CONTRACT Change ORDER NO.8

DATE: 5/18/2026

PROJECT: Lake County Sheriff's Administration Renovation  
 Project No. 250816

CE #104 - RFI #169: Report Writing | Countertop
Report Writing Room Owner Requested countertops.

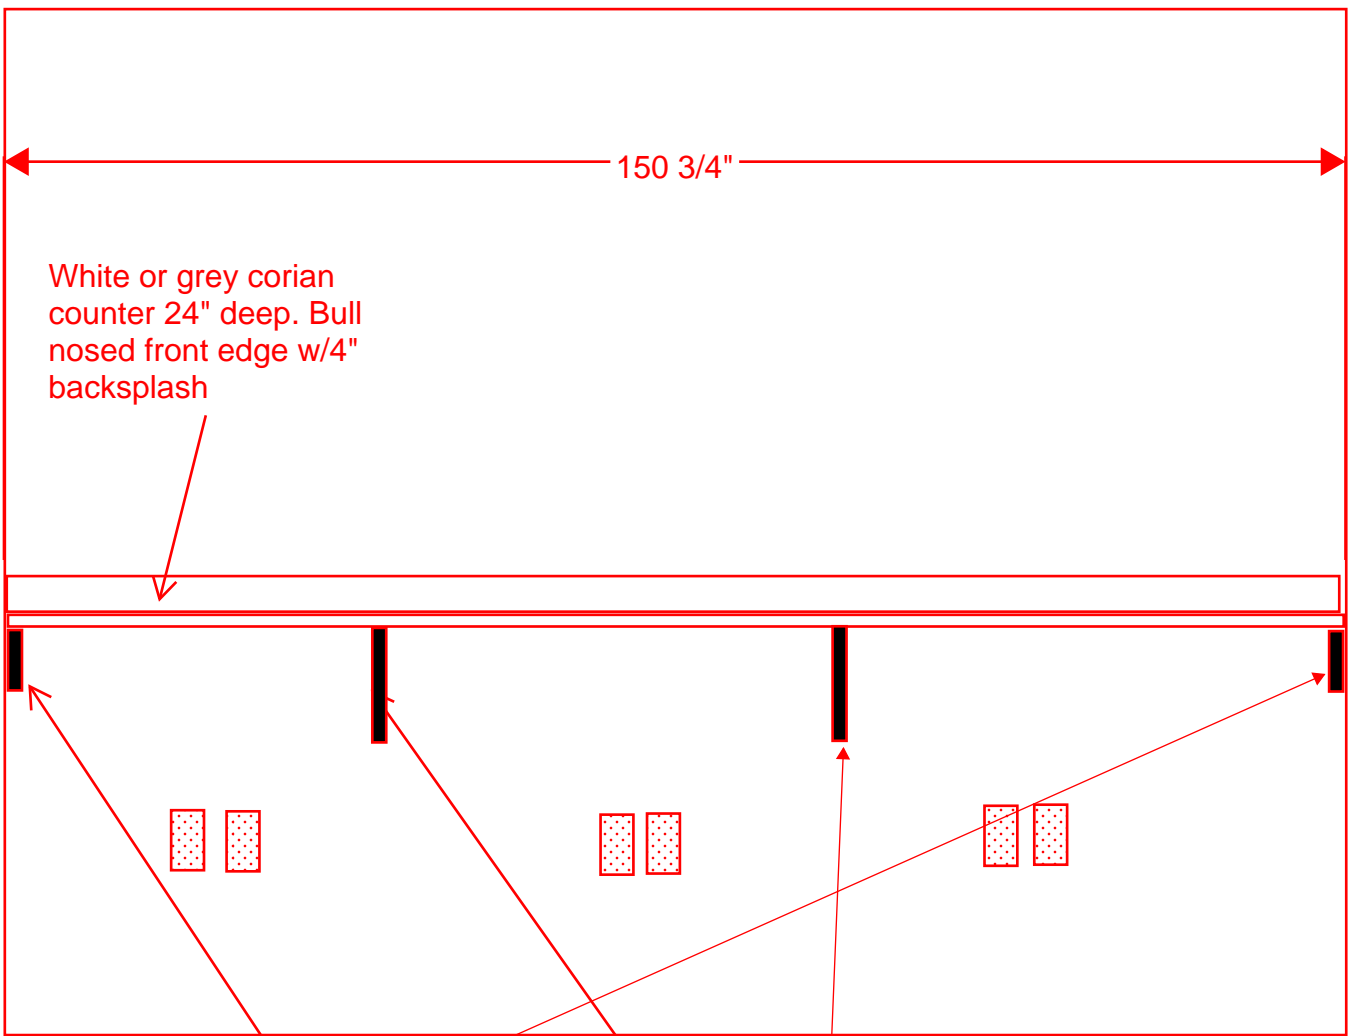
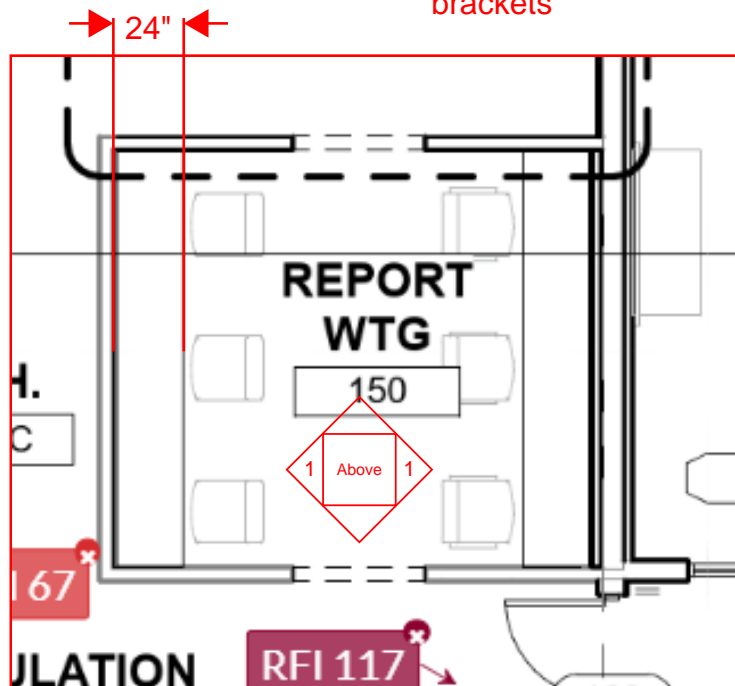
PLEASE SEE THE QUOTE BELOW TO PROVIDE AND INSTALL TWO (2) CORIAN COUNTERTOPS AT REPORT WRITING RM 150 PER DETAILS ATTACHED.

CE #104 - RFI #169: Report Writing | Countertop
Report Writing Room Owner Requested countertops.

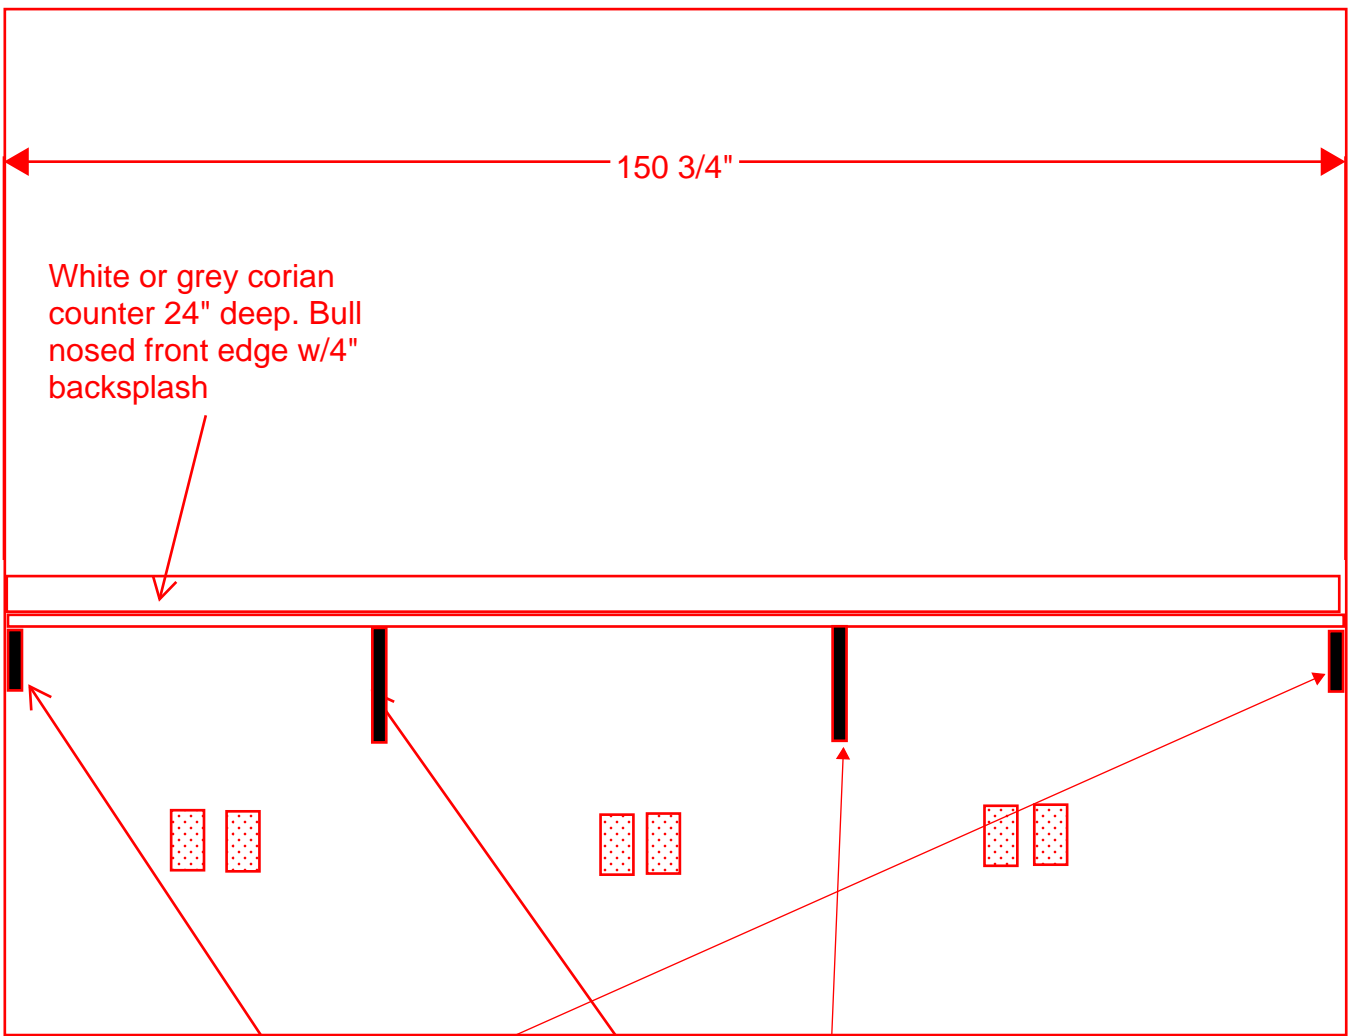
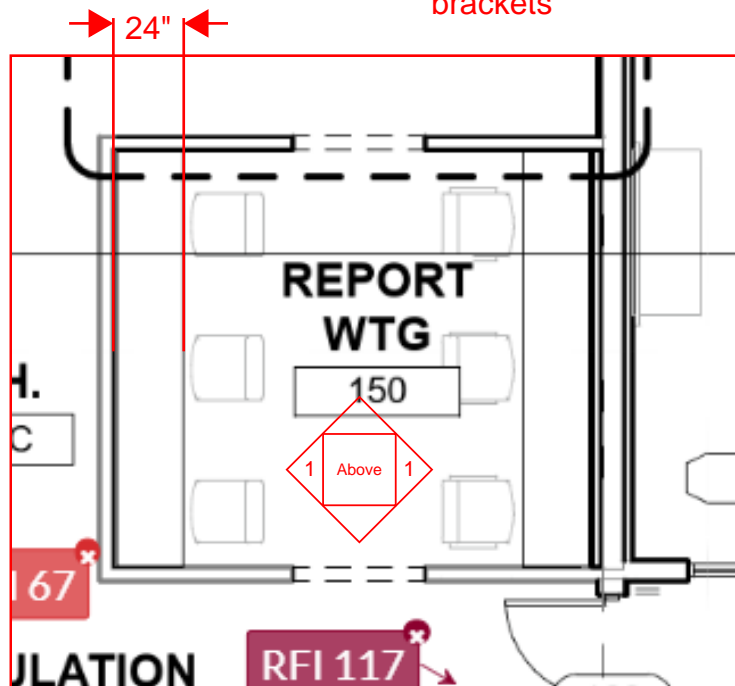
PLEASE SEE THE QUOTE BELOW TO PROVIDE AND INSTALL TWO (2) CORIAN COUNTERTOPS AT REPORT WRITING RM 150 PER DETAILS ATTACHED.
